HISTORIC AND DESIGN REVIEW COMMISSION

March 21, 2018

HDRC CASE NO: 2018-113
ADDRESS: 718 DAWSON ST
LEGAL DESCRIPTION: NCB 570 BLK 6 LOT 5
ZONING: RM-4, H
CITY COUNCIL DIST.: 2
DISTRICT: Dignowity Hill Historic District
APPLICANT: Jose Ramirez
OWNER: Jose Ramirez
TYPE OF WORK: Install new driveway spanning 12 feet in width
APPLICATION RECEIVED: February 28, 2018
60-DAY REVIEW: April 29, 2018
REQUEST:

The applicant is requesting a Certificate of Appropriateness for approval to install new concrete driveway spanning 12 feet in width.

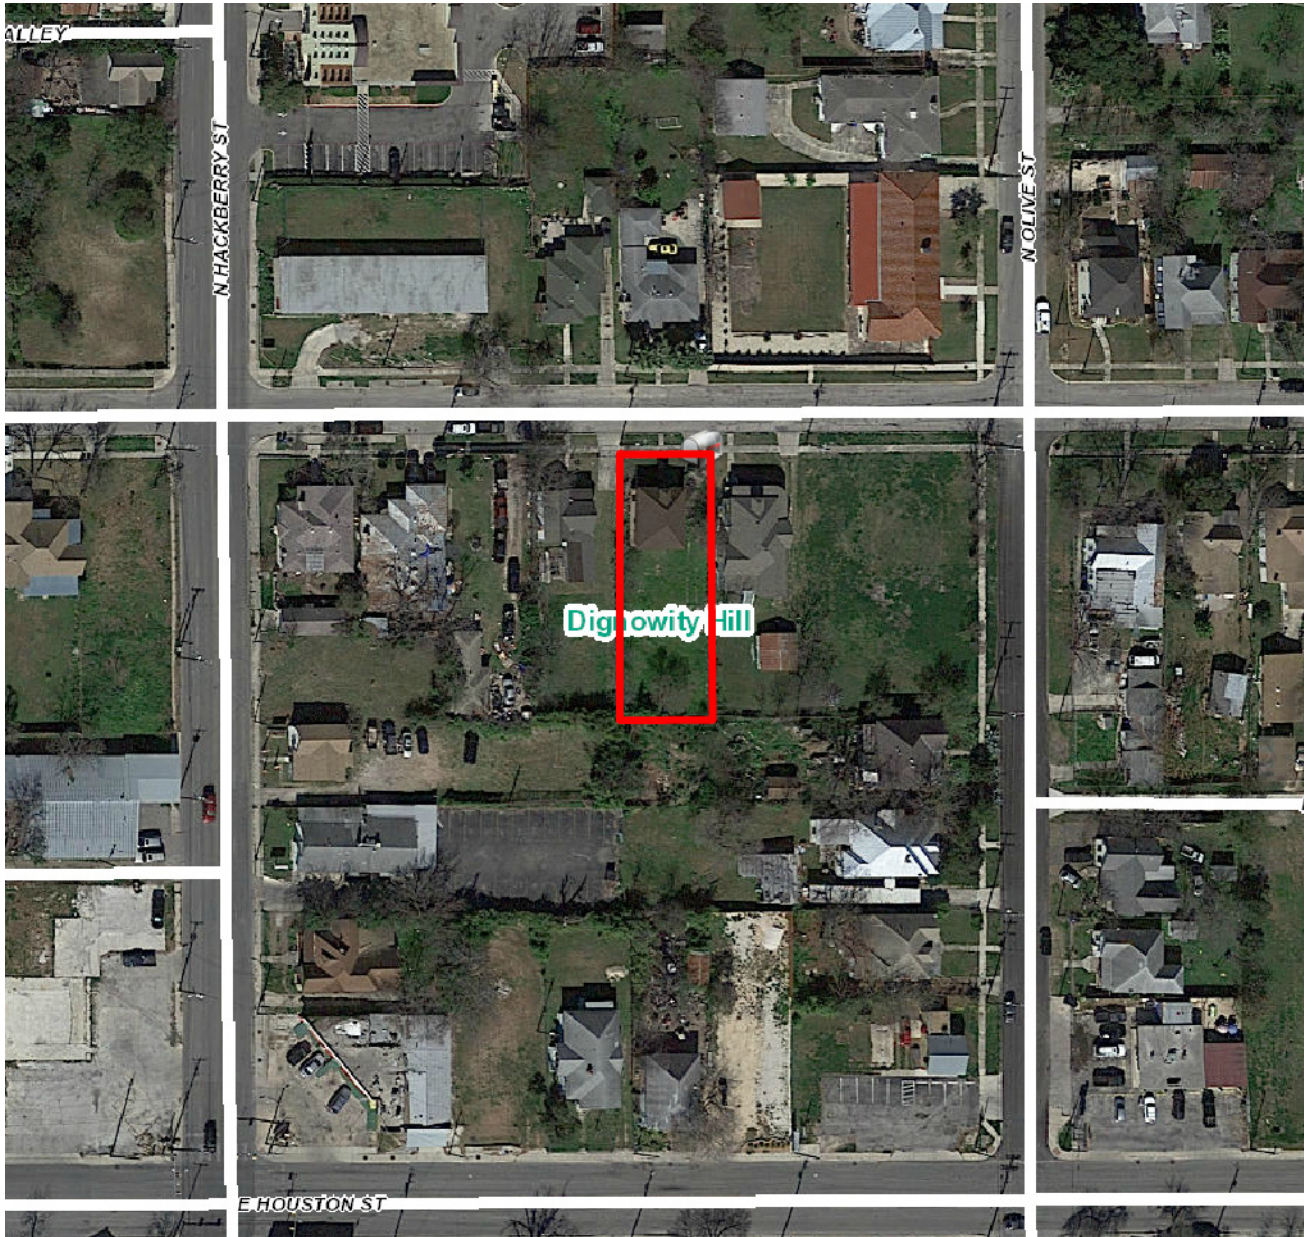
- a. The historic structure at 718 Dawson is a Folk Victorian structure constructed circa 1915. The structure features one-story with a wraparound porch, wood siding, a hipped roof with composition shingles and a front dormer.
- b. DRIVEWAY – The applicant has requested to install a driveway featuring twelve feet in width. Per the Guidelines 5.B.i, driveways should feature no more wider than 10 feet in width. The proposed driveway is not consistent with the Guidelines. The driveway has been installed prior to receiving approvals.
- c. The applicant has proposed to modify the corners of the new driveway to meet the existing approach at its ten foot width while tapering to the twelve foot width as currently installed. While not consistent with the Guidelines, staff finds this proposal an appropriate approach toward mitigation of the inconsistent driveway.

Staff does not recommend approval of the 12 foot driveway as installed based on findings b. Staff recommends the driveway be reduced to ten (10) feet in width to meet the approach and tapering to no more than twelve (12) feet in width toward the end of the driveway.
